**Planning Commission Meeting
6:00 PM Tuesday, April 21, 2020**

TO: Planning Commission
FROM: Jerry Haddix, Village Administrator
RE: Case 20-08P, Site Plan Review for McDonald's
DATE: April 17, 2020

Staff Report for McDonalds Site Plan

SHEET: L1.0

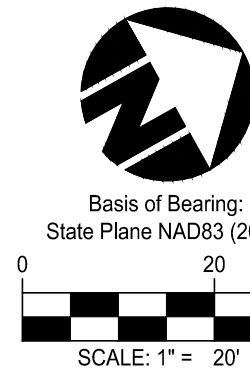
- 15.17.5; All parking lots must be screened and the screen must be 10'-0" wide with a 30" continuous screen planting or decorative wall. There must be 1 deciduous tree per 30 lineal feet. There is 230 linear feet by 6'-0" area along the parking lot side of the lot (south) shown on the plans for landscaping. **8 trees are needed with a continuous screen – 8 trees (Sweet Gum and Honey Locust) and 38 shrubs that are shown along the south side of the parking lot. There are 15 total trees and 40 shrubs shown on the north side with roughly the same length of parking lot. The width of the screening is 4'-0" less than required.**

Given the width of the lot, the parking spaces and building, the 10 foot landscape buffer is not feasible for this site. With the adjoining commercial uses, a 6-foot buffer as shown on the plans would be adequate. Also, operationally, McDonald's doesn't require a designated loading space as part of their business. Therefore, waiving of this requirement would not be detrimental to the development.
